**CITY OF BLOOMINGTON
PLAT COMMITTEE AGENDA**

**BLOOMINGTON PLAT COMMITTEE
STAFF REPORT
LOCATION: 995 S. Clarizz Boulevard**

**CASE #: PUD-34-11
DATE: December 5, 2011**

REQUEST: The petitioner is requesting preliminary and final plat approval for a 2-lot subdivision of a 2.68 acre commercial lot.

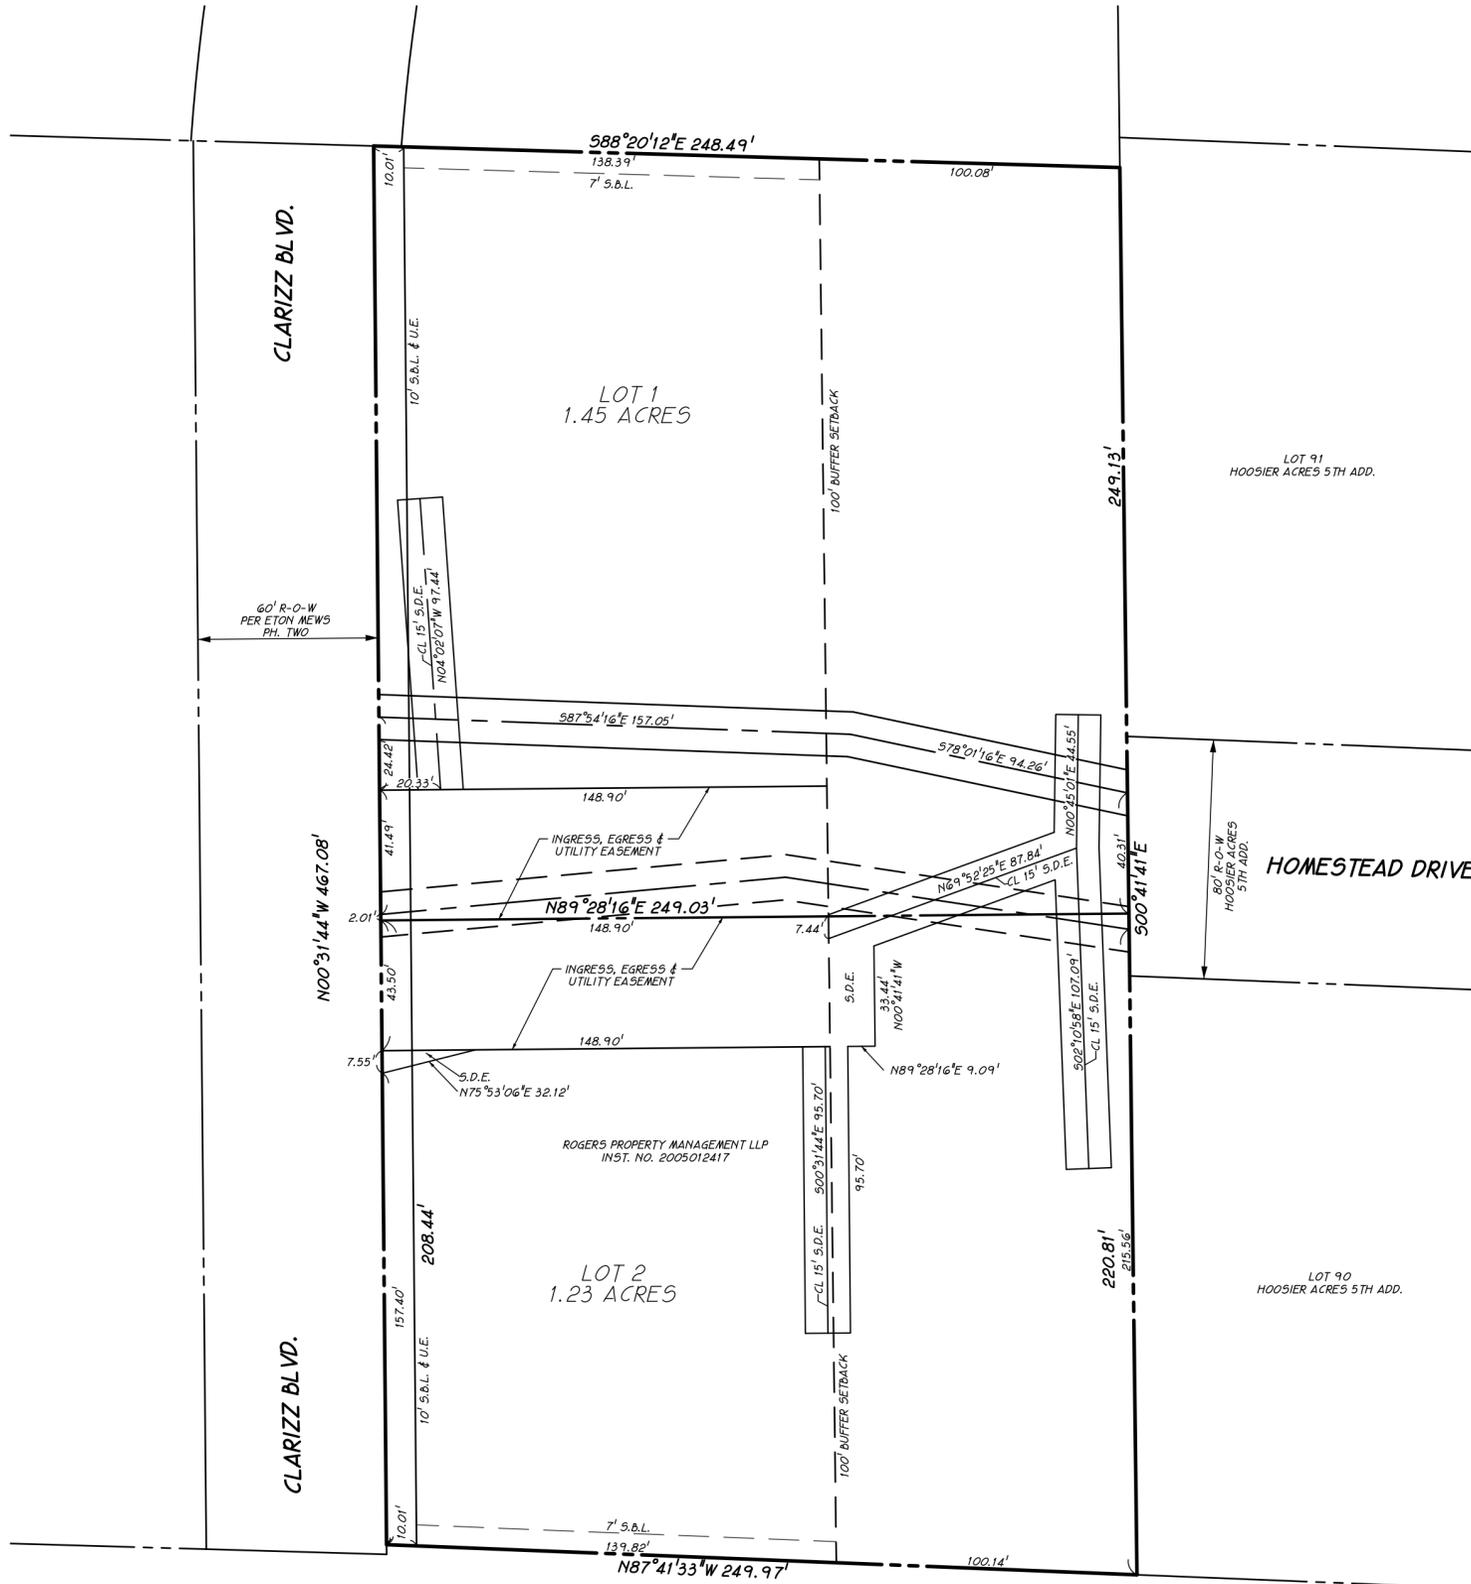
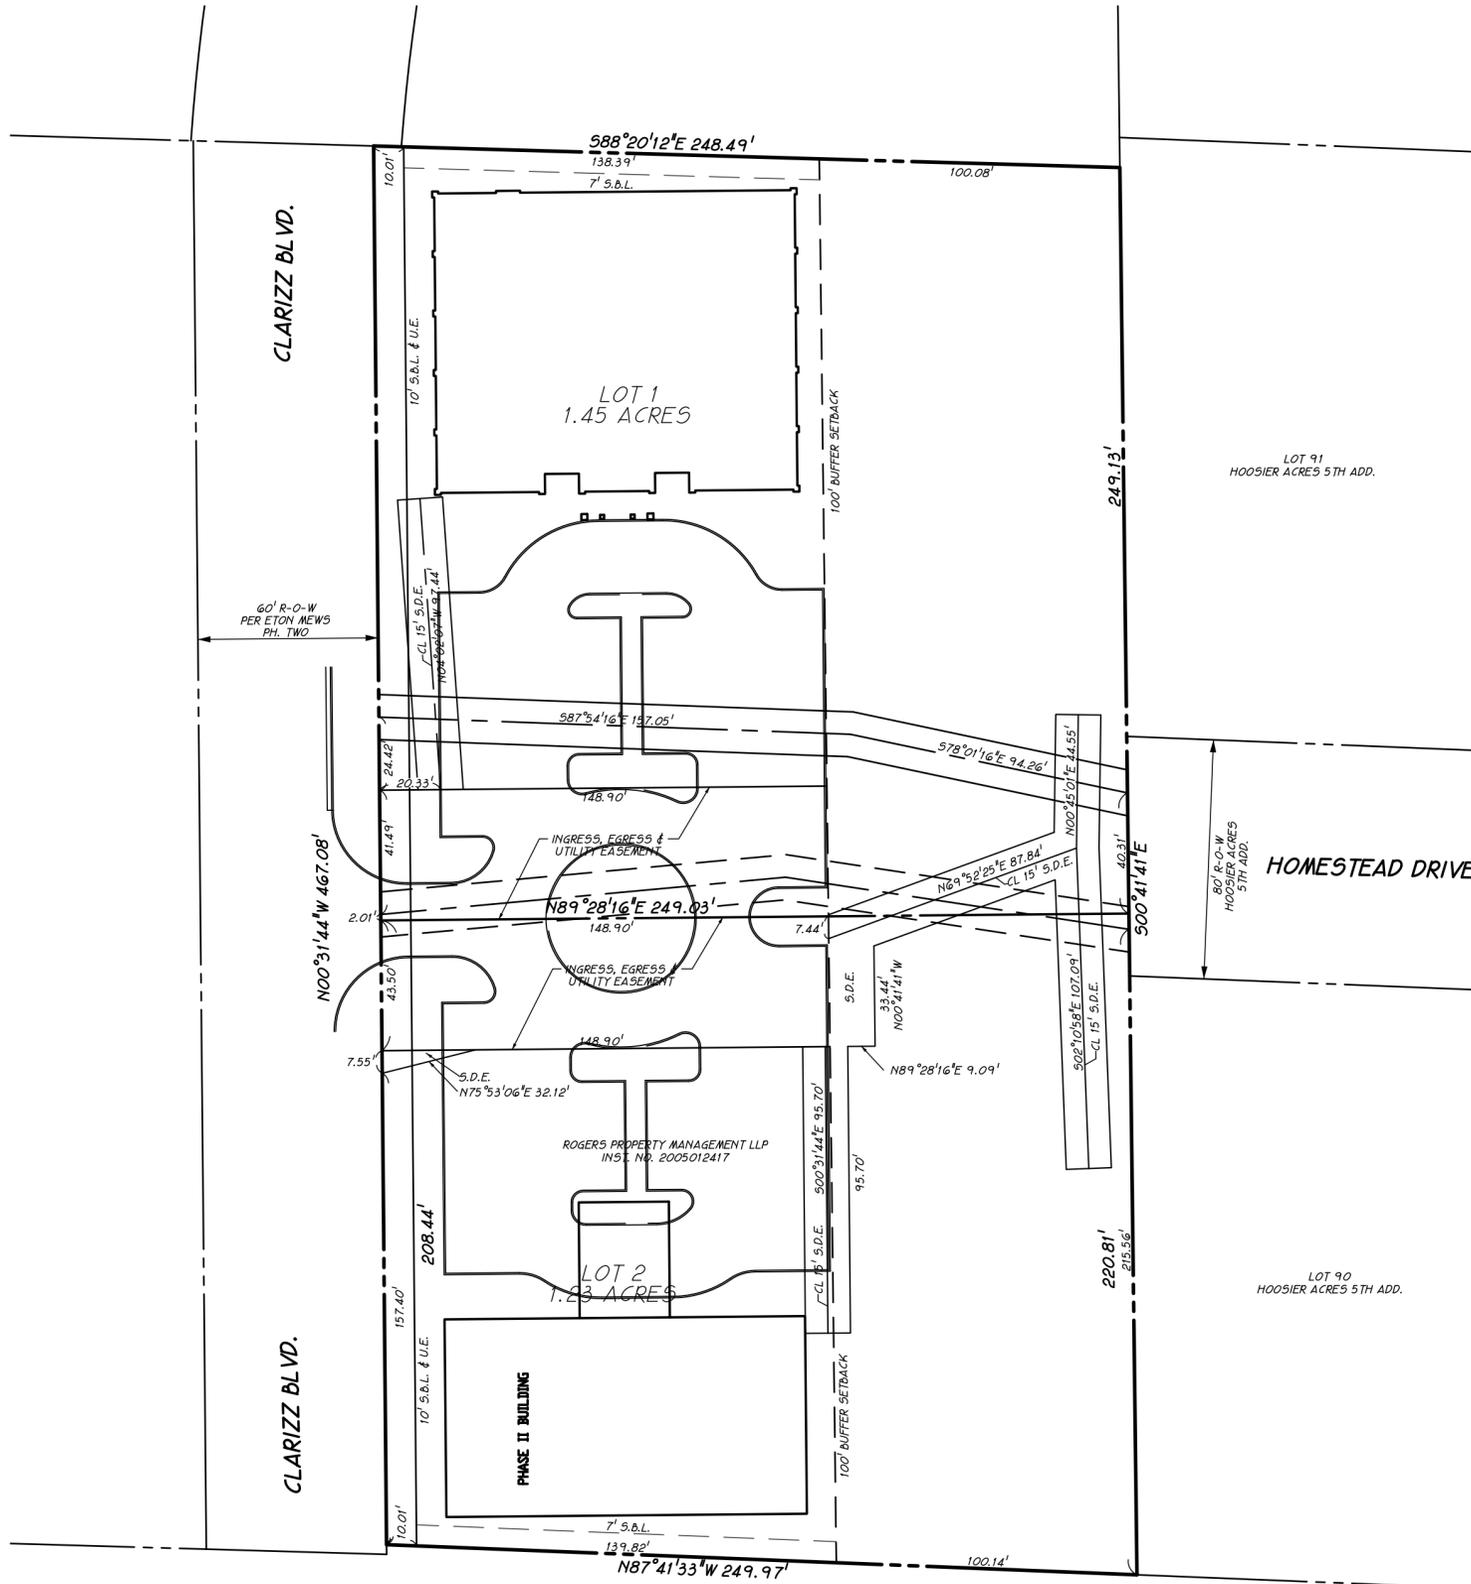
Setbacks: The plat has shown a 10-foot setback from the Clarizz Blvd. ROW. This should be relabeled "Build-to Line". The PUD required a minimum of 75% of any buildings to be built within 10' of the build-to line, with parking a minimum of 20 feet from the ROW line.

Pedestrian Facilities: An eight (8) foot wide asphalt sidepath is already in place on the east side of Clarizz Blvd and will be maintained. A pedestrian path system is proposed through the site from Clarizz Blvd, to the dead-end of Homestead Drive. This path should be placed in a pedestrian easement prior to plat signature.

1. Approved per terms and conditions of PUD-08-02 and PUD-7-11.
2. Addresses for both lots must be shown on the final plat prior to signature.
3. No additional drive access to Clarriz Blvd. is permitted.
4. 10 foot front setback line shall be revised to read "Build-to Line".
5. Pedestrian path connecting to Homestead Drive must be placed within a pedestrian easement prior to final plat signature.
